Docket Item # 11 & 12  
BAR CASE # 2018-00374  
2018-00375

BAR Meeting  
September 19, 2018

**ISSUE:** Partial Demolition/Capsulation and Alterations

**LOCATION:** 203 S Union Street

PROPOSED ROOF PLAN

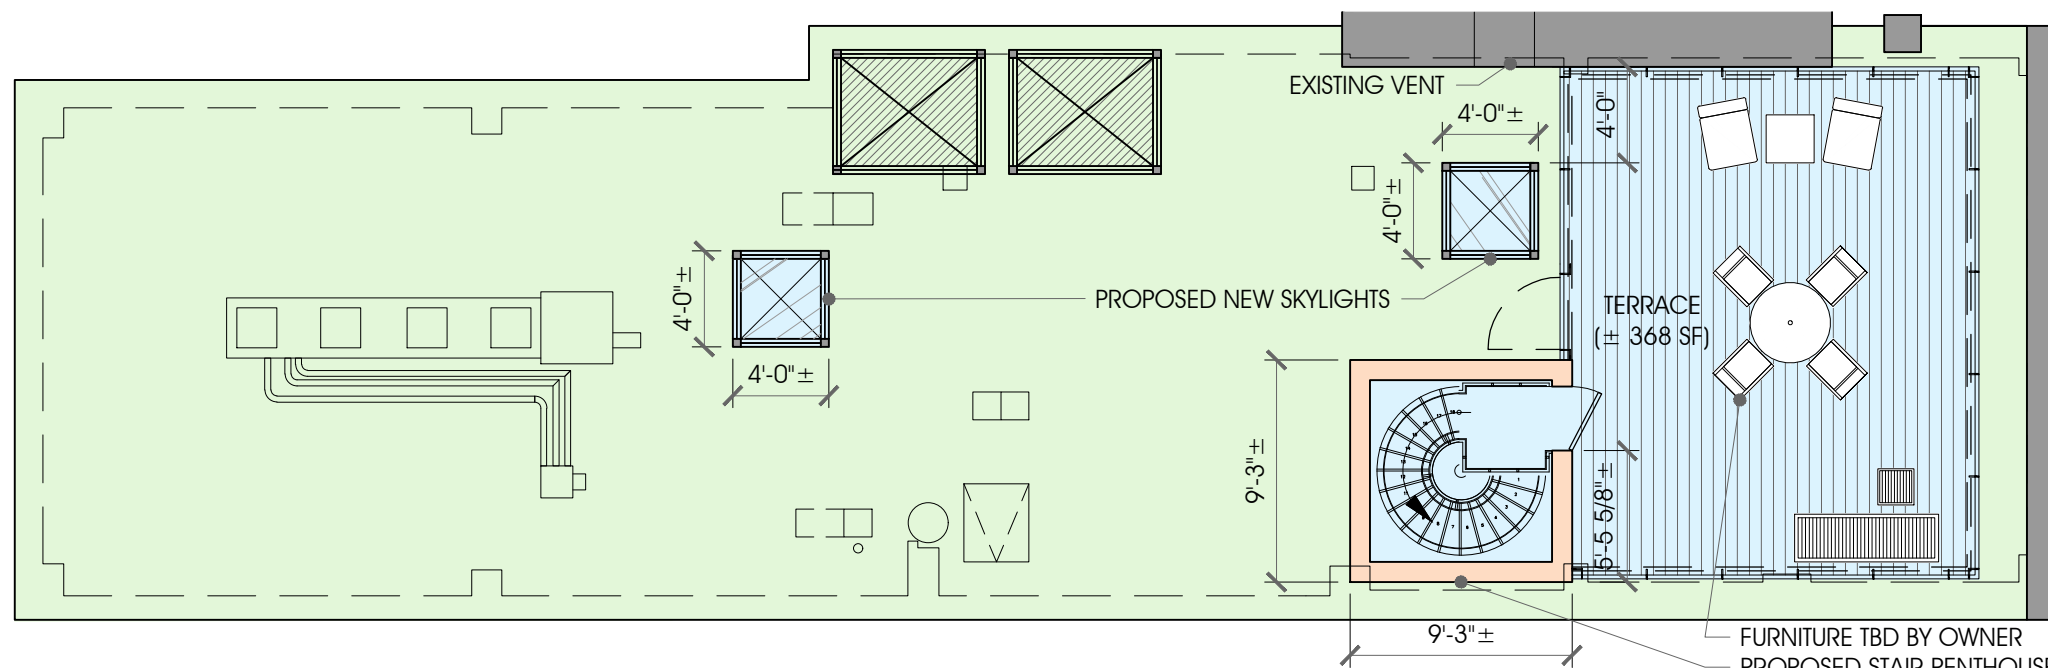
1. That the roof of the stair penthouse be a flat or low-sloped roof form.

Staff supports the application as submitted, with a minor refinement to the penthouse design. The stair penthouse will be located 19' from the front building wall and the potential visibility from the public street is low. While the penthouse will be minimally visible, and then only from certain vantages, staff nevertheless recommends that the proposed gable roof should be a flat or low sloping roof to be consistent with the roof-form of the historic warehouse building.

SECTION DETAIL AT RAILING

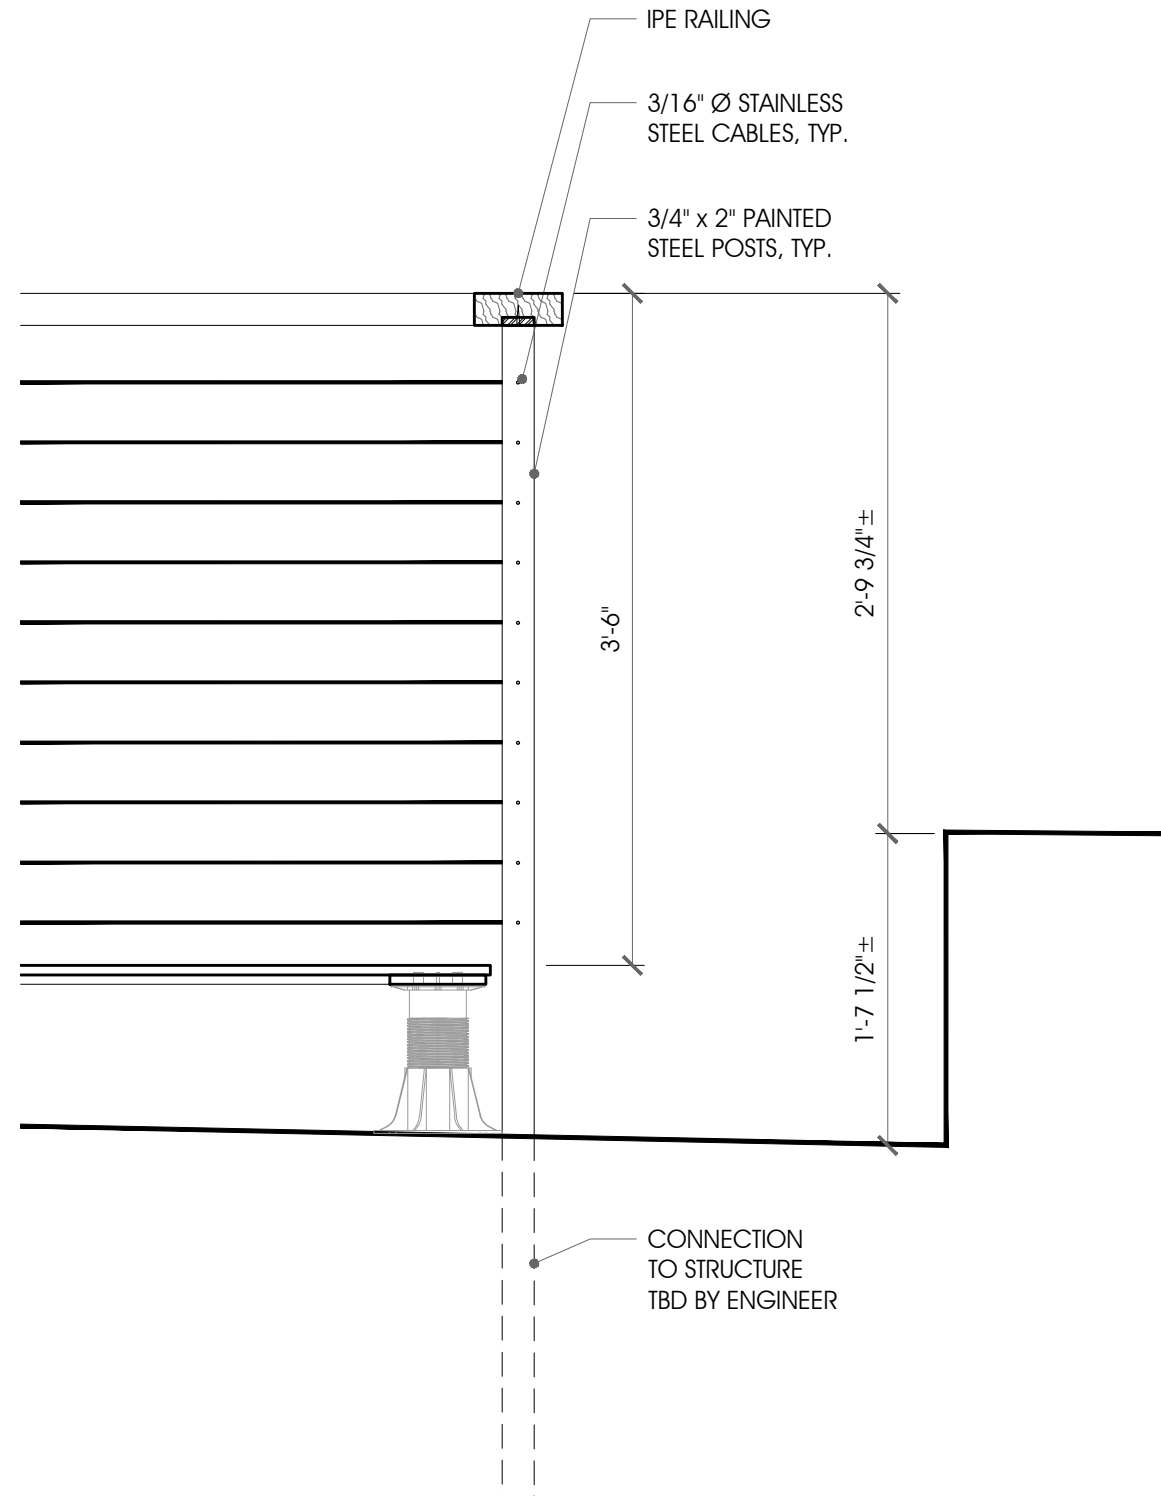
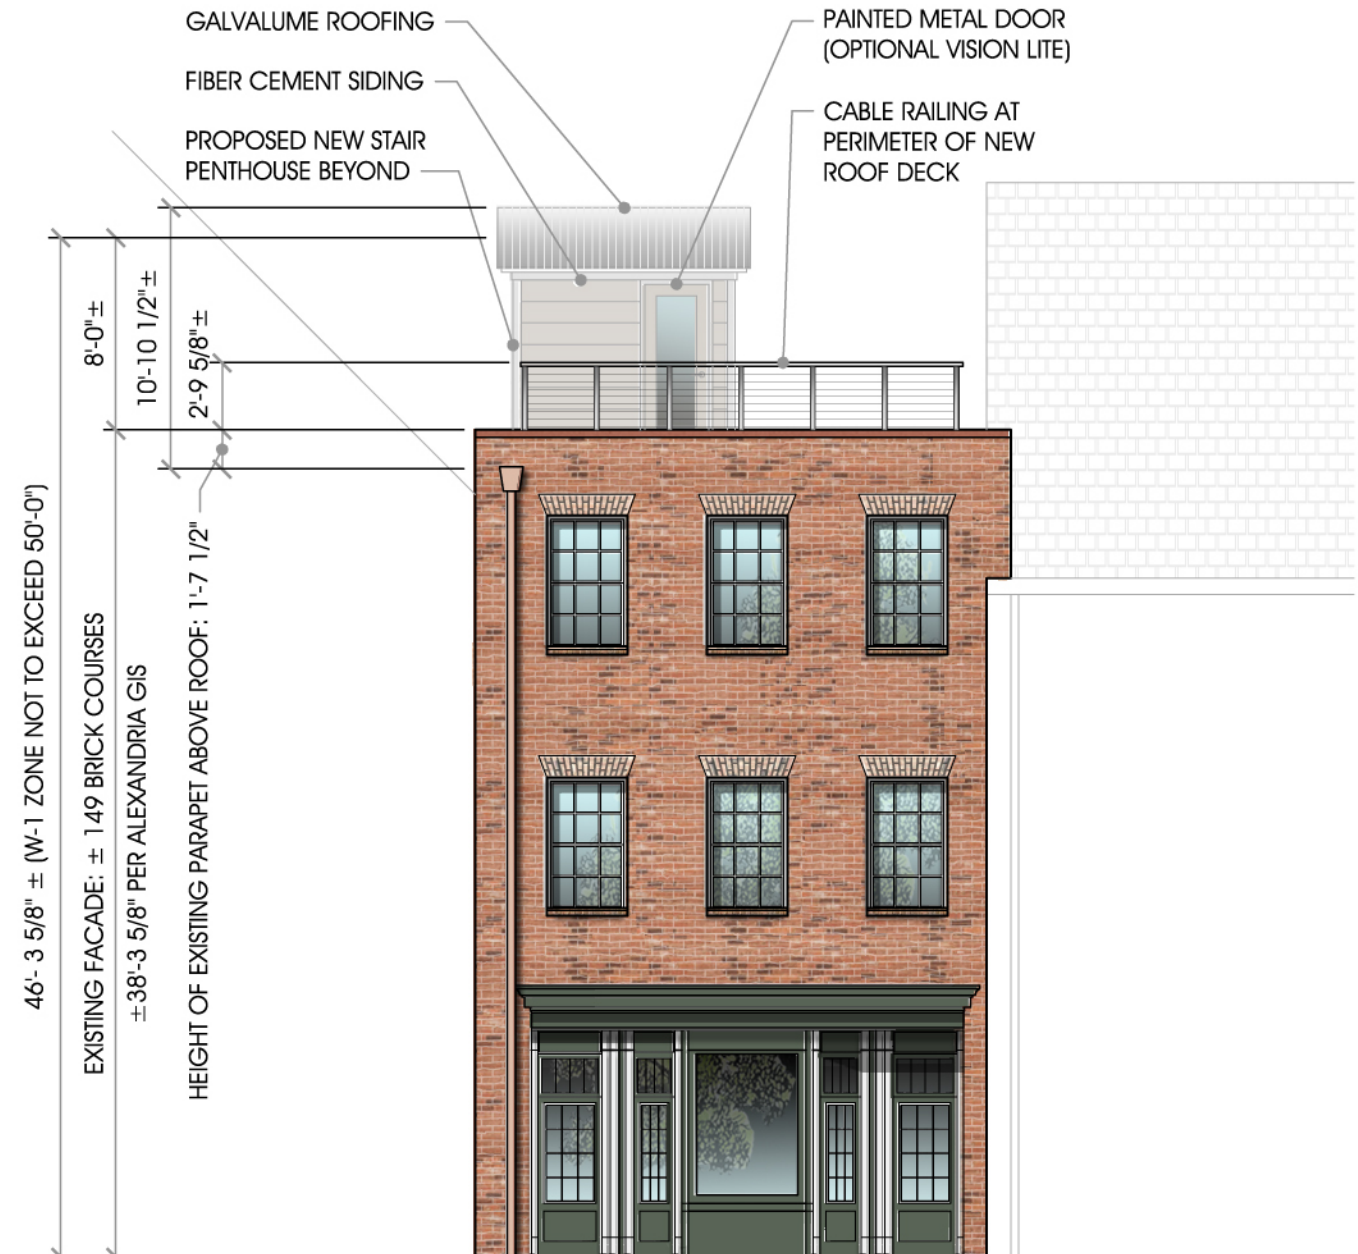
The proposed aircraft cable guardrail for the roof deck is set approximately 2' behind the existing parapet wall and only 2'-9" of the proposed railing will project above the parapet. Therefore, the minimal, contemporary design of the railing – which staff supports in this application -- will be only minimally visible, if at all. Staff also supports the applicant's effort to clearly differentiate the penthouse from the historic structure by using fiber cement siding in a neutral color. This enables the historic building to remain the primary focus of visibility.
